(NEW) Q+A QUESTIONS + ANSWERS – Questions submitted through September 26, 2025

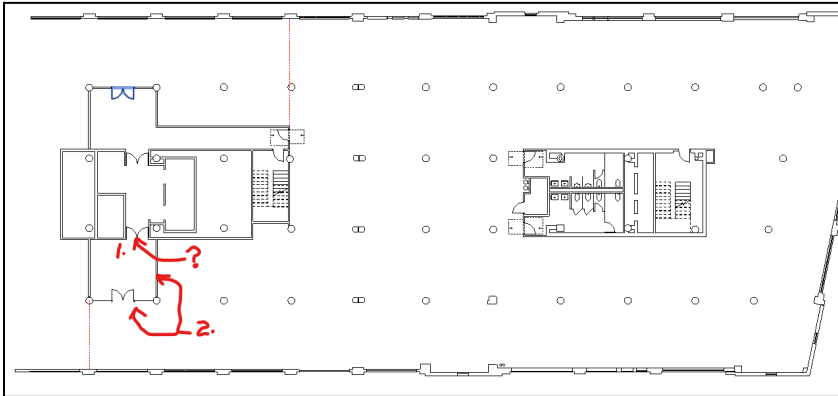
Q: Is the sub-lobby to the south of the elevator also considered part of the core space, or are students free to eliminate walls and doors south of those leading directly to the elevator lobby (door and walls #2)? I can hold this question until the official Q&A if it is not deemed appropriate at this time.

A: Door #1 cannot be eliminated. Door and walls #2 may not be eliminated; however, if your students would like to take advantage of this space for branding (which can be removed if they leave as a tenant), that is permitted. The location of door #2 can be moved if the student researches local codes and requirements and verifies if moving the door meets the local codes.

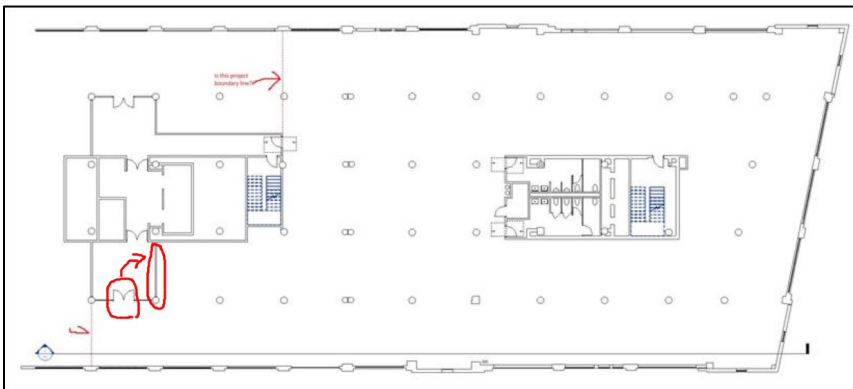
Q: Some of the students asked if they can change the location of the entrance from the southside glass wall to the east side wall.

A: The location of the can be moved if the student researches local codes and requirements and verifies if moving the door meets the local codes for egress.

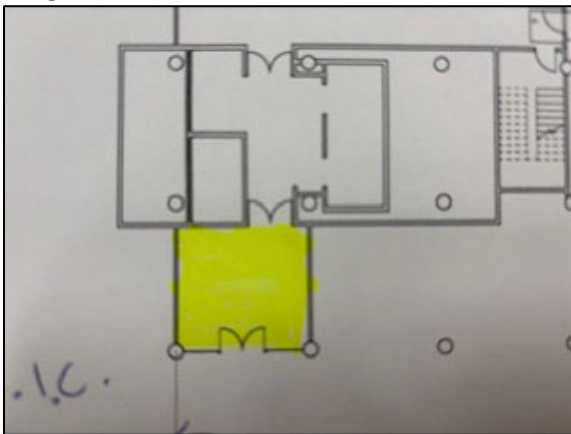
Q: Can we design the vestibule into the suite and use this square footage for furnishings or is this NIC? (see yellow in image below)

A: The vestibule should not be considered as part of the USF and is NIC. As mentioned on other Q+A shared in prior emails, the door location may be moved; however, not removed. If the student wishes to apply branding elements to the vertical surfaces of this area, that is permitted; however, furnishings should not be placed in this area.

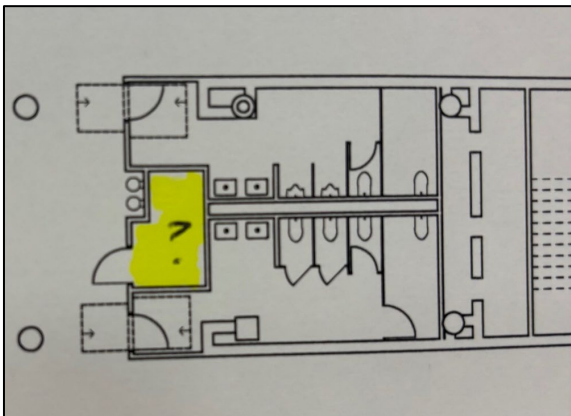
Q: What is the function of this room and can we use it or assume it's a janitor's closet, etc. and part of the NIC core?

A: Consider this to be part of the NIC (core building elements) and should not be considered as part of the design for the competition.

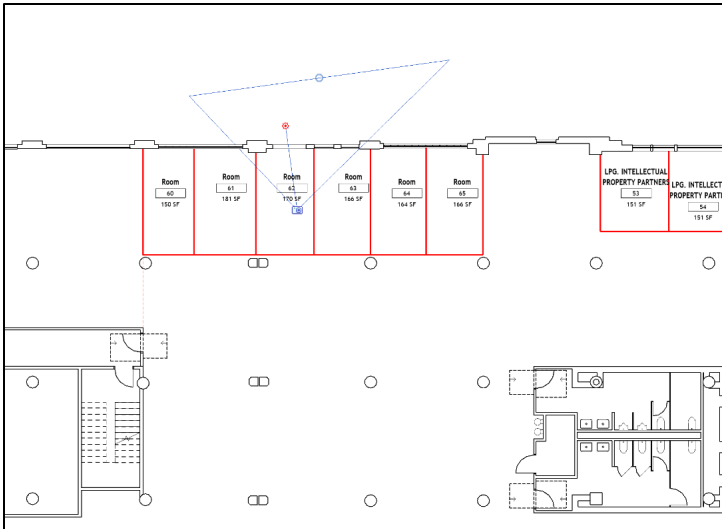
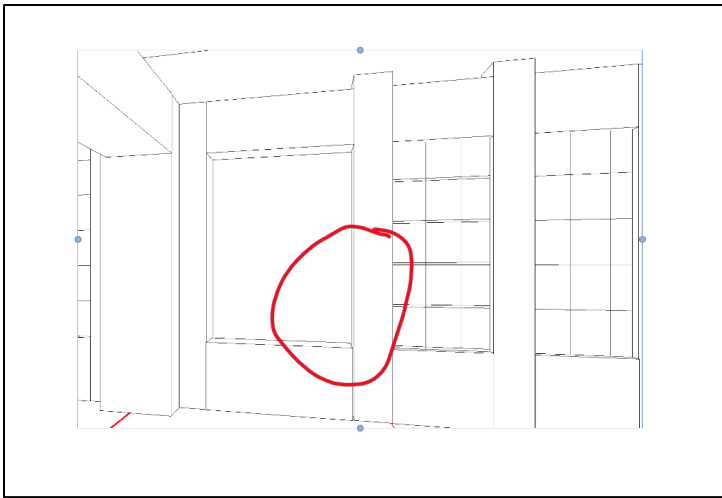
Q: One of the walls appears to have a cut out for a window in Revit, but no curtain wall. Can we assume that we will add a window there? (see image below)

A: This must be an error in the Revit model. Consider this to match all other walls/windows.

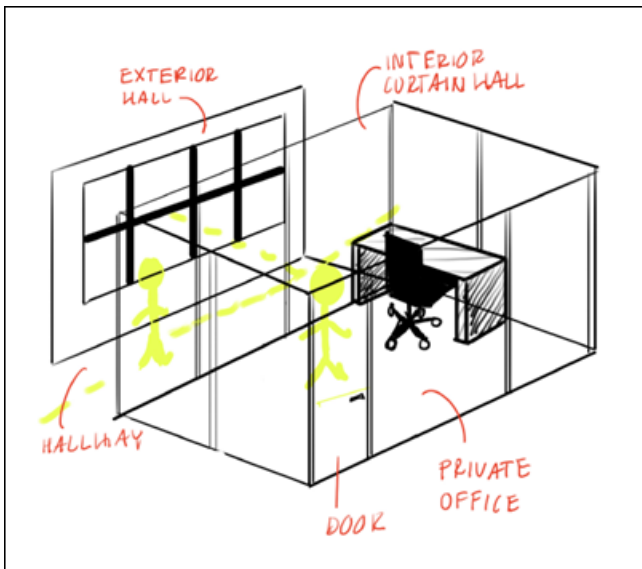
Q: Many spaces in the program are required to be adjacent to a window. Must these rooms be directly flush with the exterior wall, or can they instead be positioned along the perimeter with a glass wall facing outward, separated from the exterior windows by a hallway? See illustration below:

A: Providing such a corridor would be very unusual for a law firm to implement in their workplace. Though this is very typical for other market sectors, this is not something that has been adopted in the legal workplace as they most likely wouldn't provide this valuable real estate along the glass for a full-length corridor. If this was to be implemented in a few areas based on unique space planning constraints, it would be acceptable if the student can defend their design intent and design decision for doing so.
